**AGENDA**  
**TULSA METROPOLITAN AREA PLANNING COMMISSION**  
**Meeting No. 2751**

August 2, 2017, 1:30 PM  
175 East 2nd Street, 2nd Level, One Technology Center  
Tulsa City Council Chamber

### Z-7401 – (CD 3)

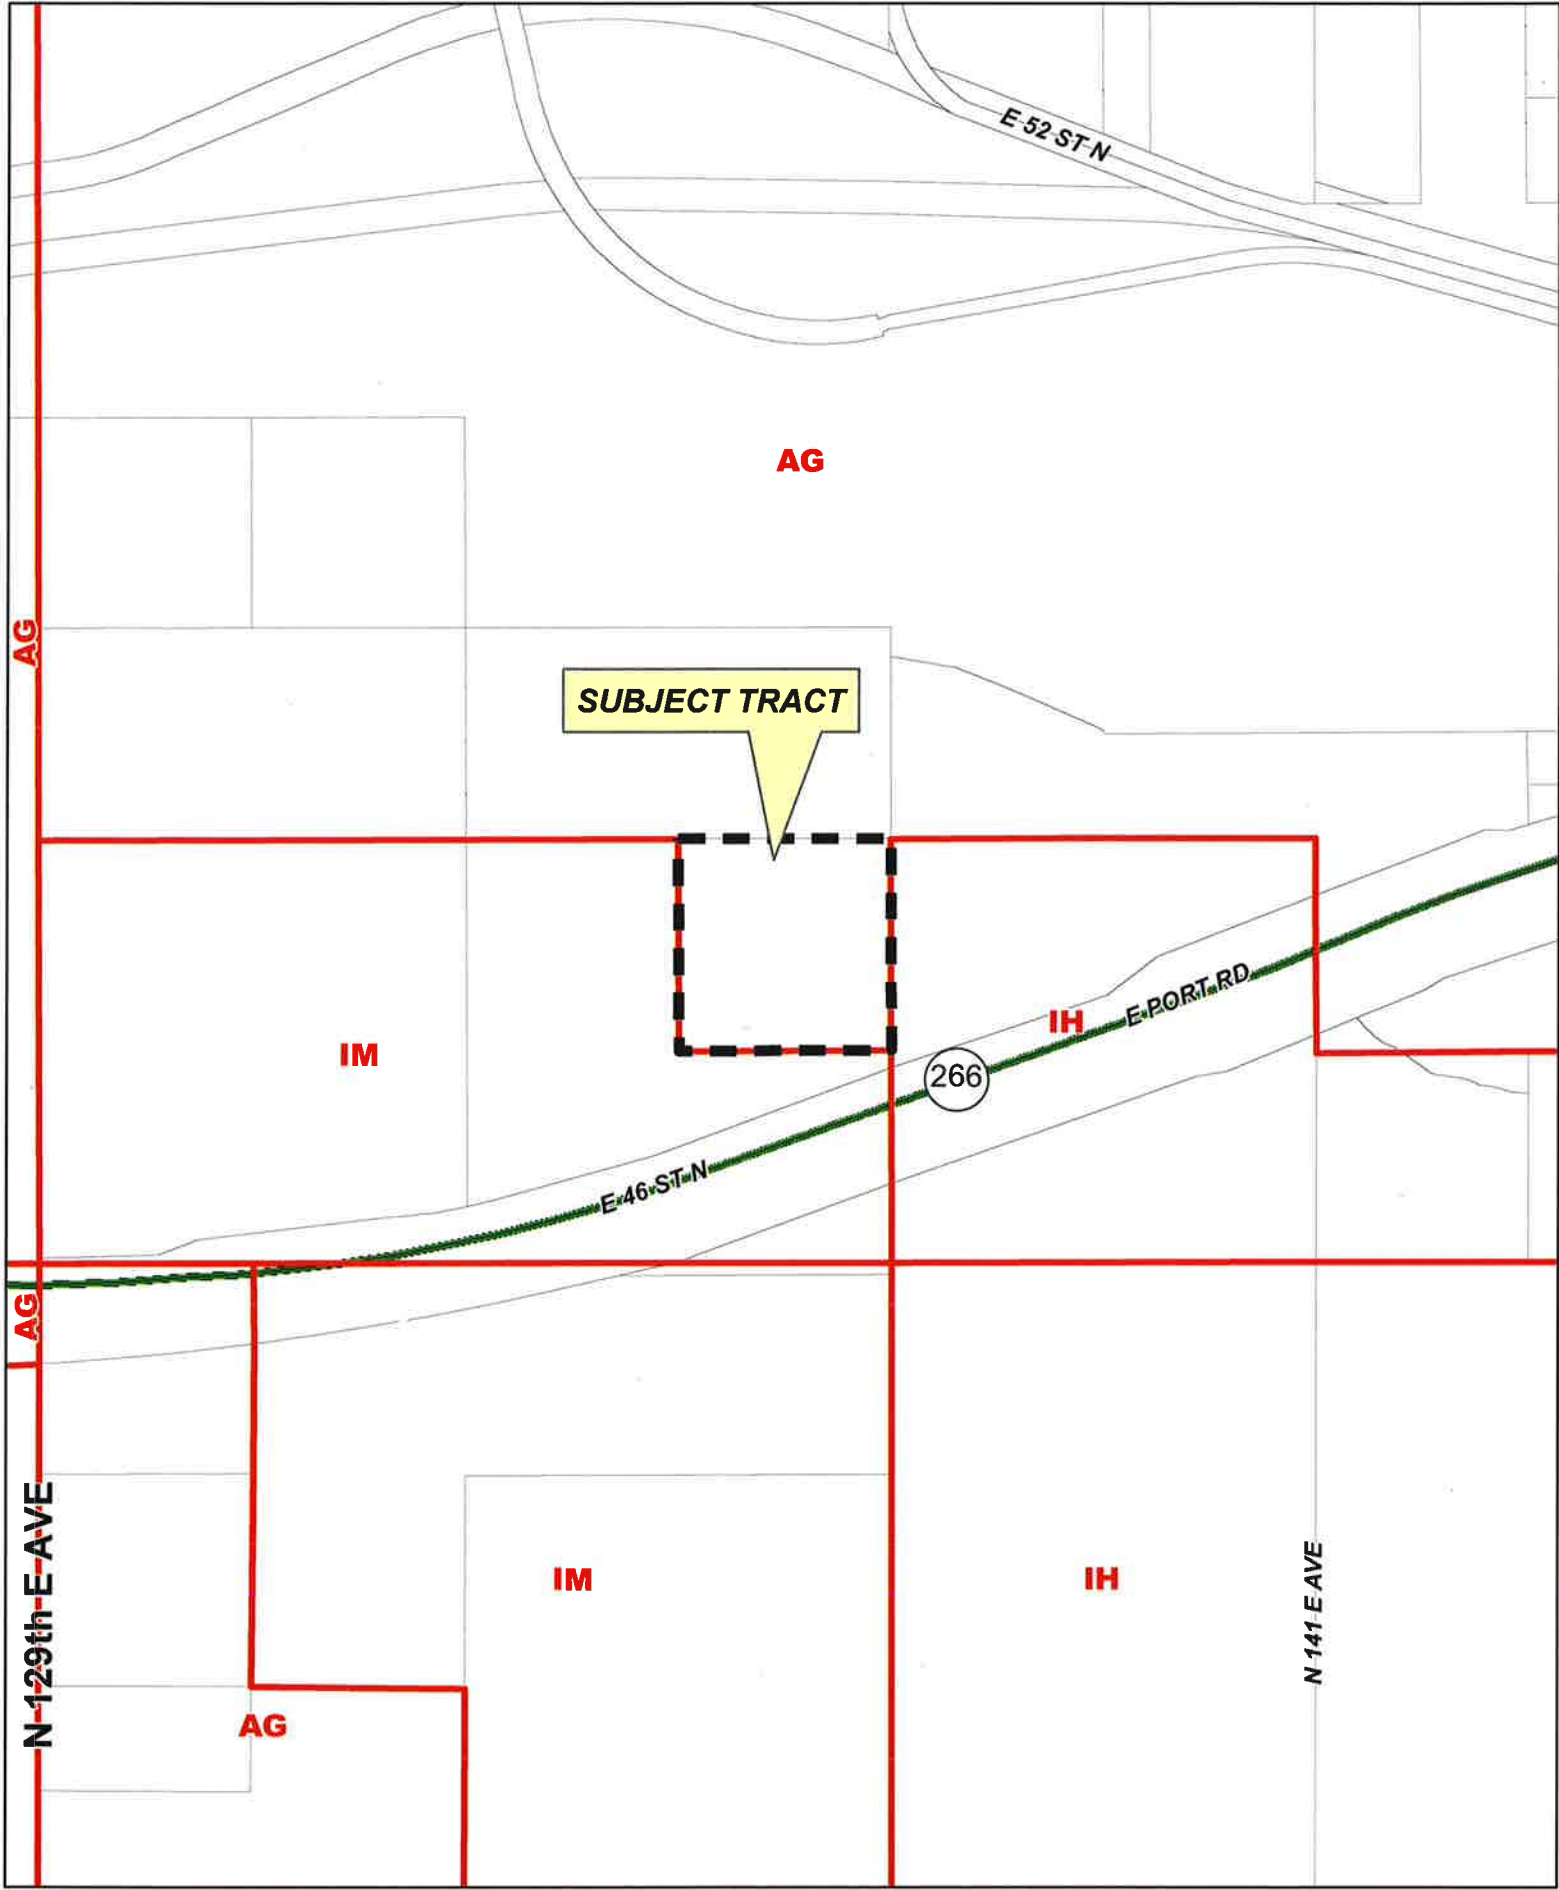
The platting requirement for this property is being triggered by an approval to rezone the property from AG to IH. Per Section 70.080-B, the City of Tulsa Zoning Code requires platting of any property that has been rezoned to accommodate the intensification of land use possibilities typically associated with a zoning map change.

The Technical Advisory Committee met on June 15, 2017 and the following items were determined:

1. The property under application has never been platted.
2. There have been no plats filed on any adjacent property to the site.
3. Currently, the property under application has no access to a public street. To acquire access, the property would need to be combined with adjacent unplatted property or provided an access easement.
4. Water line extension will be required. The existing 24" concrete line cannot be tapped for service. A parallel 12" water main line will be required along the property frontage.
5. There is currently no sanitary sewer service on site.
6. Any new structure on-site will require the installation of fire hydrants compliant with International Fire Code 2015 coverage requirements.
7. 46<sup>th</sup> Street North is State Highway 266. Access limitations should be applied and will need Oklahoma Department of Transportation approval.

Due to the unplatted nature of the property, multiple infrastructure requirements, and the rezoning to IH, staff recommends the processing of a subdivision plat on the property and **denial** of the plat waiver request.

### Z-7384 – (CD 2)

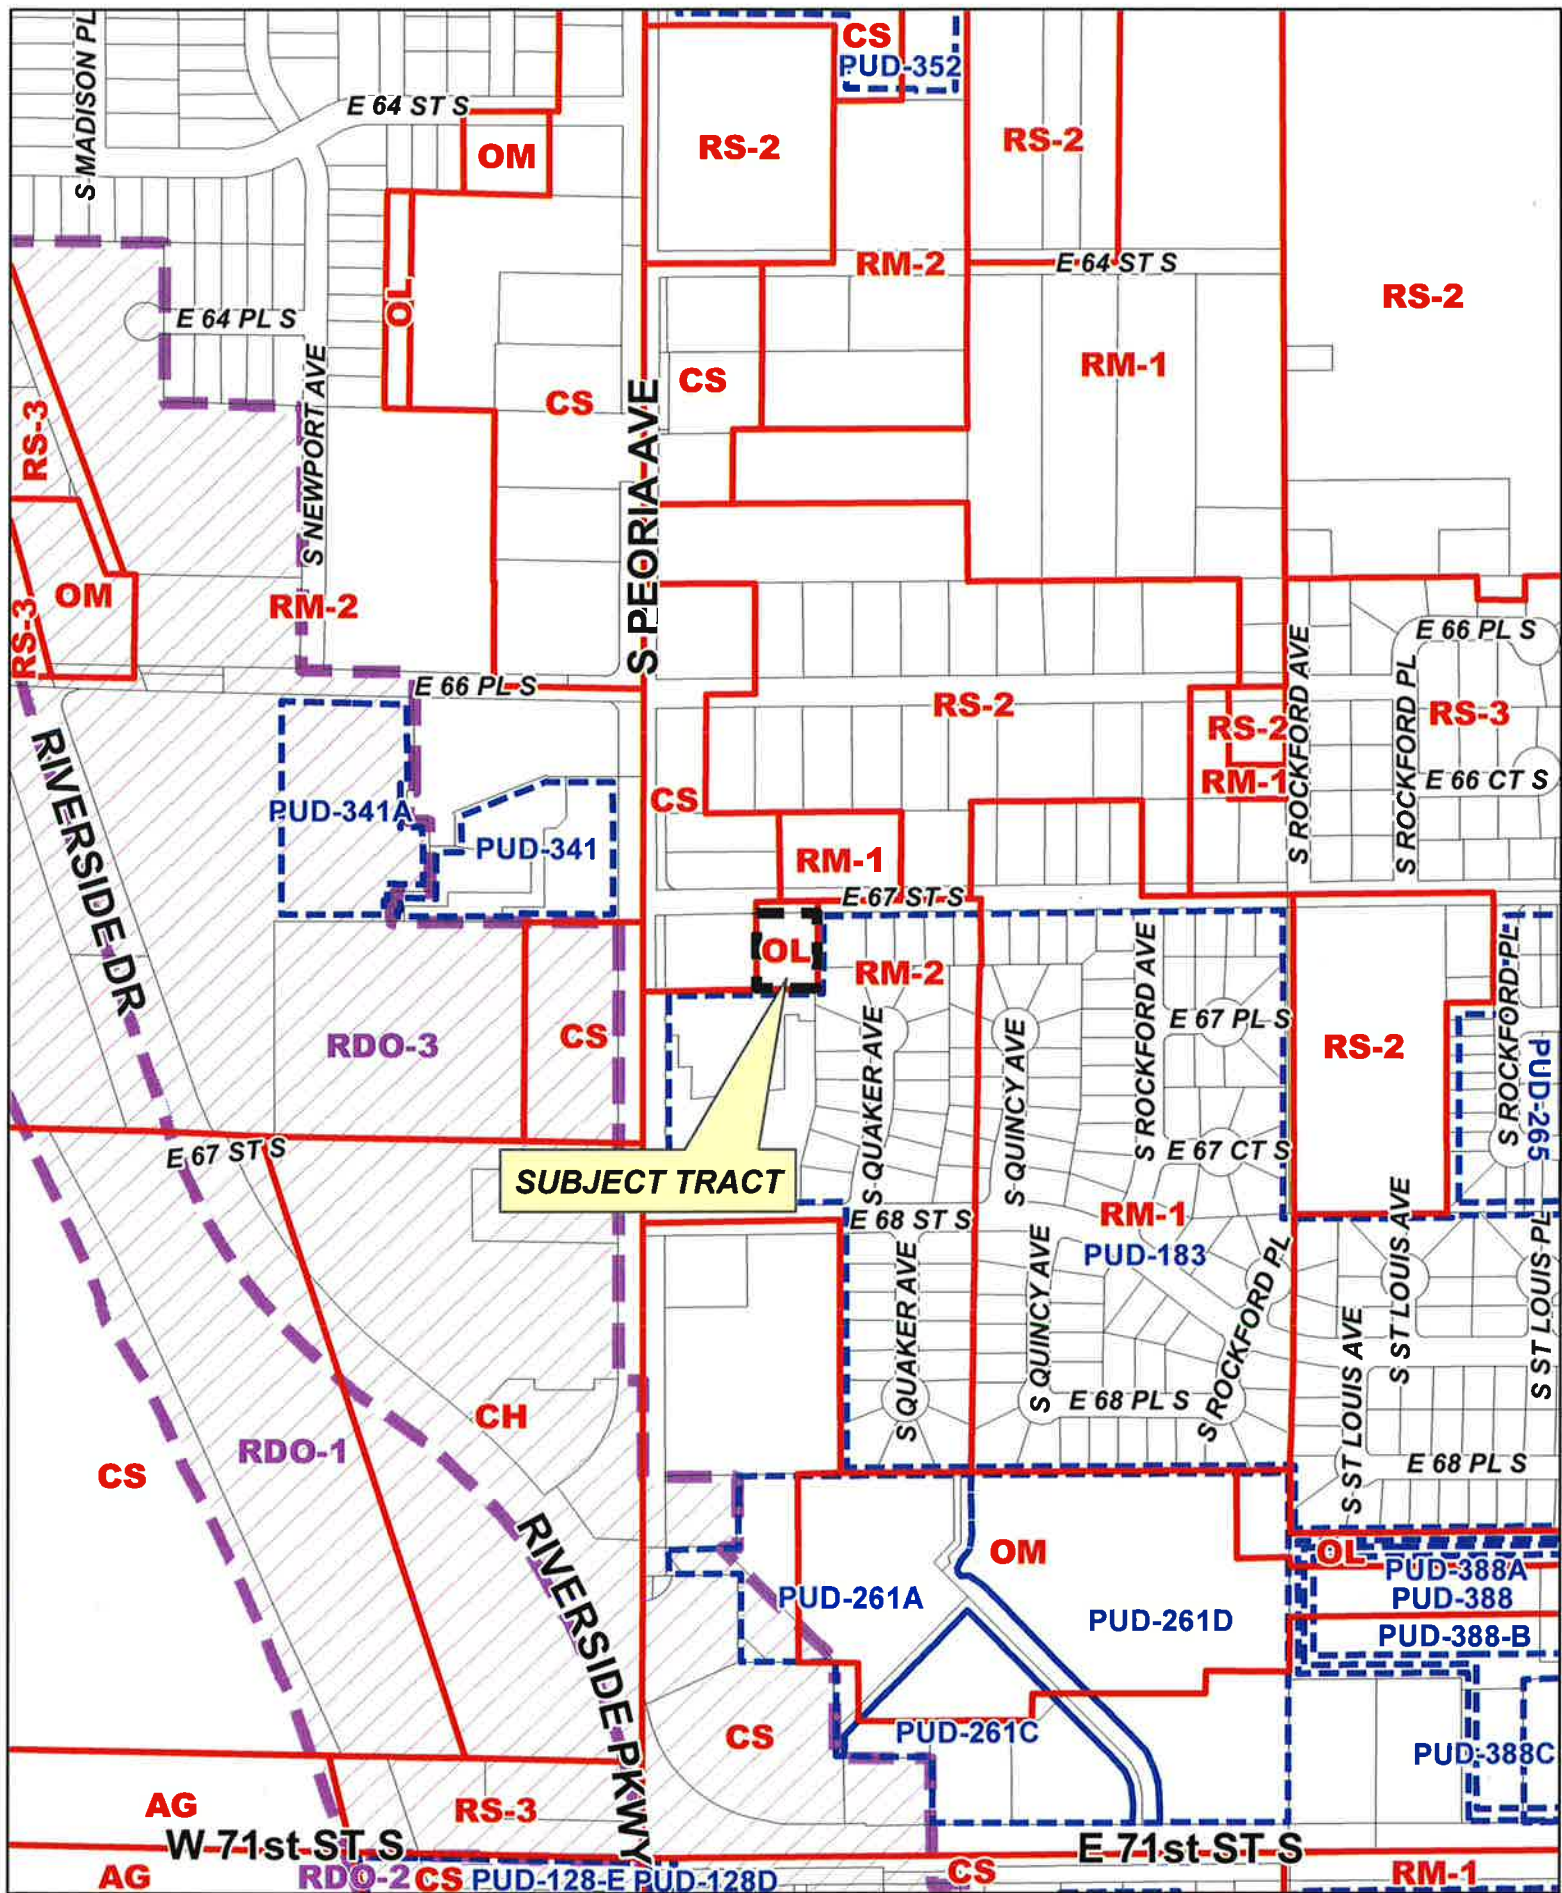
The platting requirement for this property is being triggered by an approval to rezone roughly half of the property from OL to CS. Per Section 70.080-B, the City of Tulsa Zoning Code requires platting of any property that has been rezoned to accommodate the intensification of land use possibilities typically associated with a zoning map change.

The Technical Advisory Committee met on June 15, 2017 and the following items were determined:

1. The property was previously platted under the Keim Gardens Addition plat.
2. Adjacent property to the east and south has been platted.
3. Right-of-way dedications for South Peoria Avenue and East 67<sup>th</sup> Street have all been made.
4. Water service is available on site through existing 8" waterline.
5. Sanitary sewer is being extended to site and will require an additional easement. Easement will be obtained through IDP process.

Staff recommends **approval** of the plat waiver.

### **Northstar Estates** - (County)

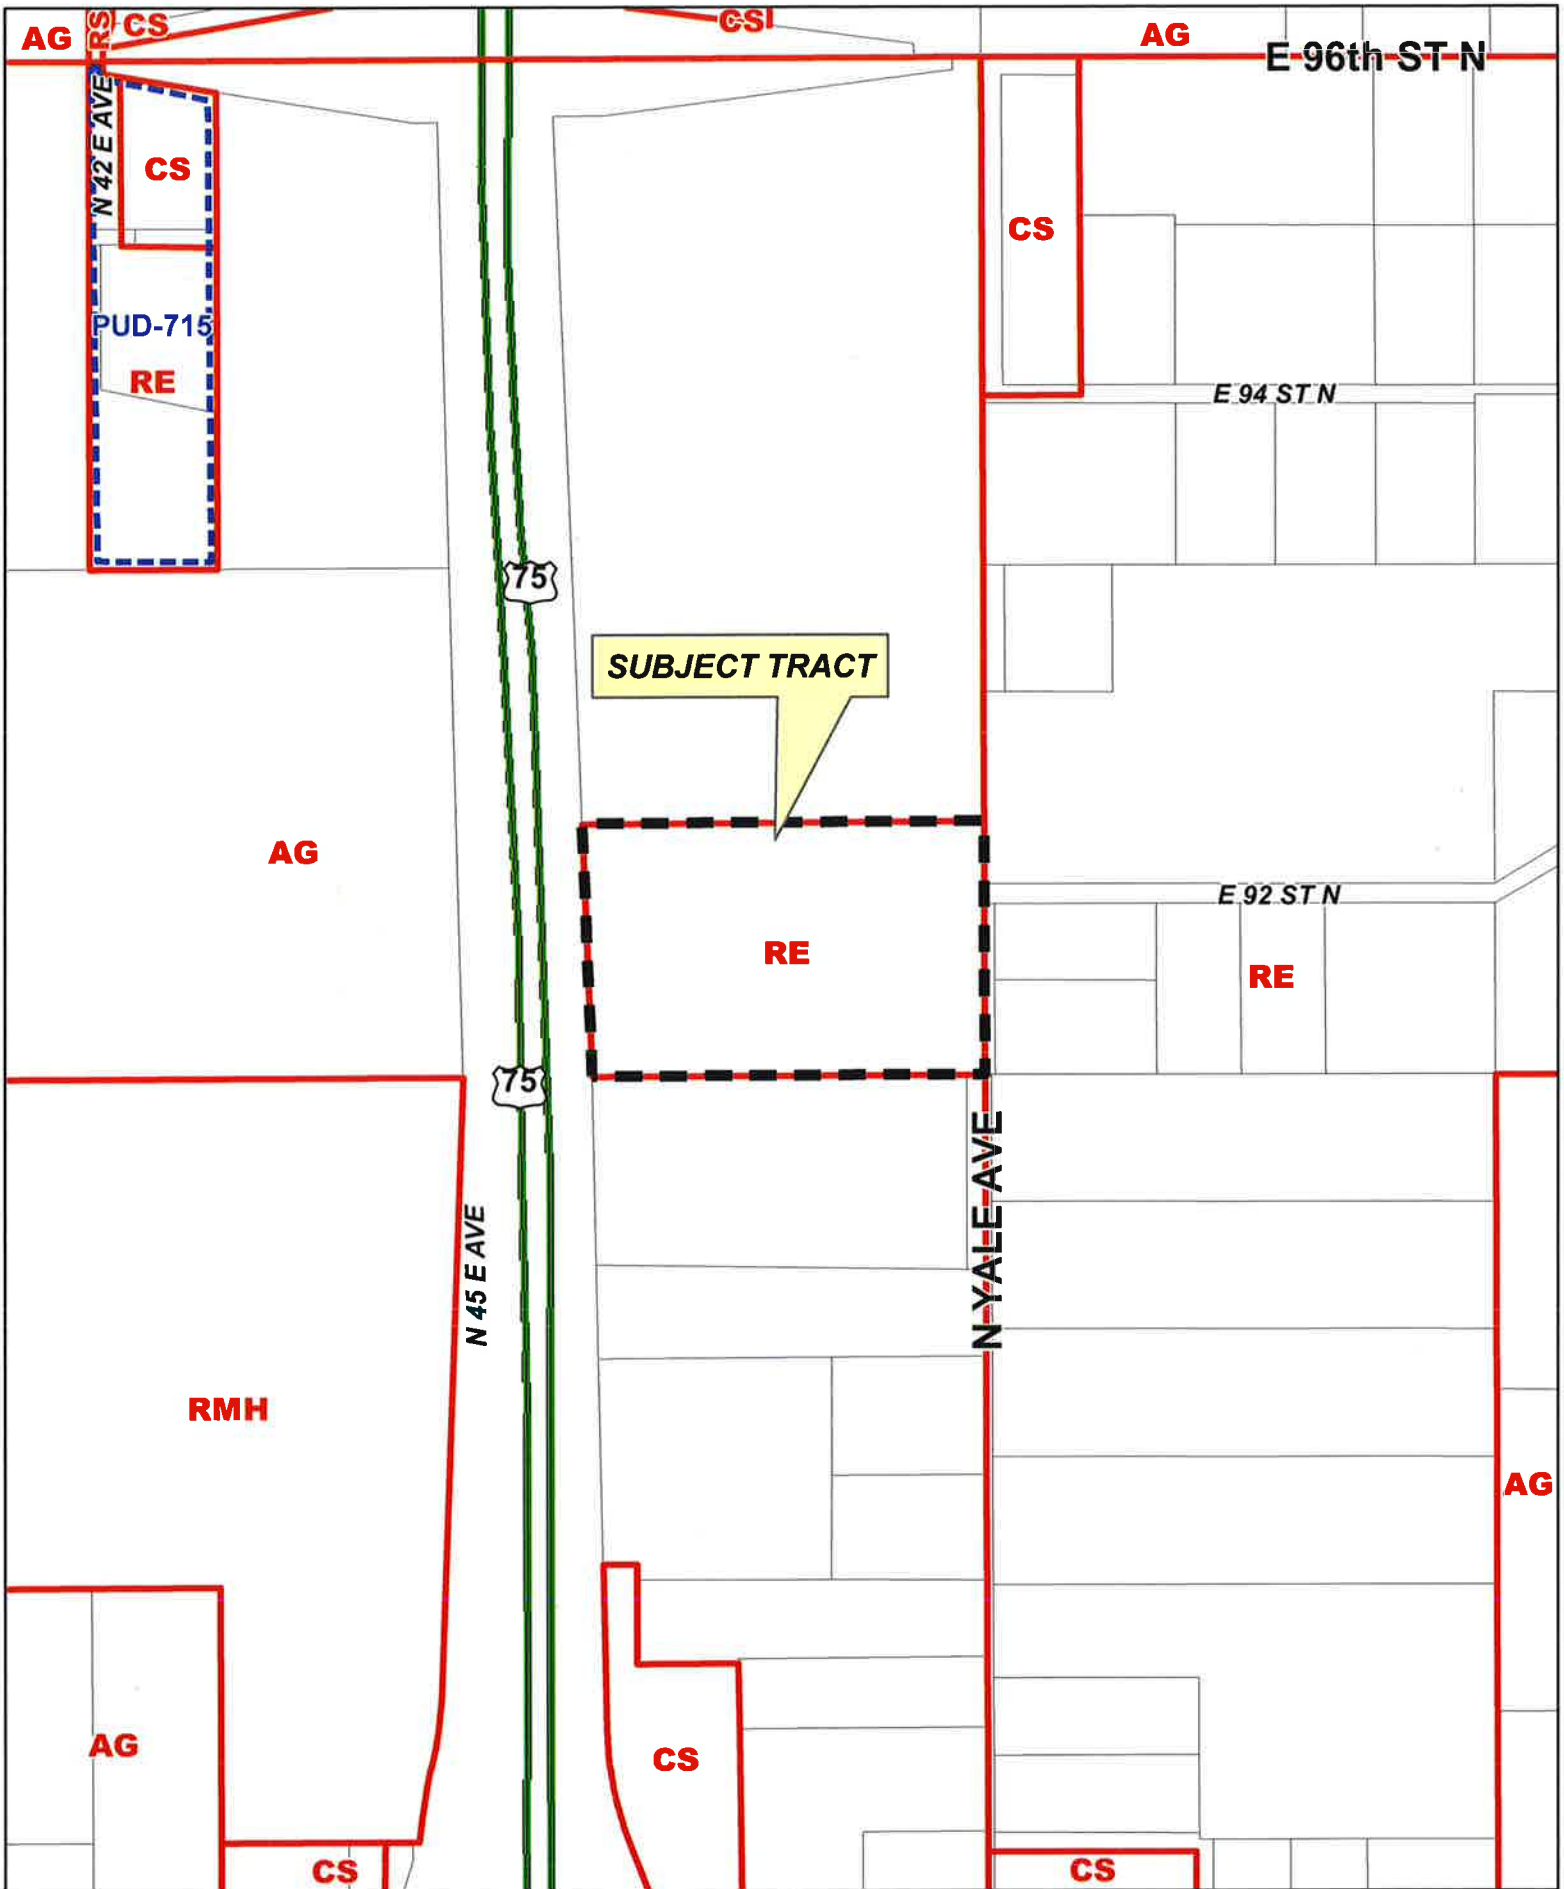
1. **Zoning:** All property within the subdivision has been rezoned to RE (Residential – Estate). All proposed lots conform to the requirements of the Tulsa County Zoning Code.

2. **Addressing:** Addresses will be assigned by INCOG.
3. **Transportation & Traffic:** Provide 25' radius for intersection with North Yale Avenue. Label access and limits of no access along North Yale Avenue.

4. **Water:** Water line plans must be submitted to Rural Water District No. 3, Washington County. All requirements of the district must be met for final plat approval.

5. **Engineering Graphics:** Submit a subdivision control data sheet with final plat. Provide addresses for individual lots on final plat. Remove contours from the face of the final plat. Provide a scale and a north arrow for the location map. Show only platted subdivision boundaries in the location map and label all other property as "unplatted". Add street labels to location map. Ensure accuracy and consistency between written legal description and bearing angles shown graphically on the face of the plat.

6. **Stormwater, Drainage, & Floodplain:** Drainage plans must comply with Tulsa County standards. Any required easements must be properly located and dimensioned on final plat.

7. **Utilities: Telephone, Electric, Gas, Cable, Pipeline, Others:** All utilities indicated to serve the site must provide a release prior to final plat approval. Provide a Certificate of Records Search from the Oklahoma Corporation Commission to verify oil & gas activity on the site. Provide plugging records for any plugged wells on site. 125' building setback is required from any active well or known well bore.

1. Applicant requests a waiver of Section 4.2.7 to permit a cul-de-sac length of 786'

Staff recommends **APPROVAL** of the preliminary subdivision plat and the waiver of subdivision regulations subject to the conditions provided by TAC and the requirements of the Subdivisions Regulations.
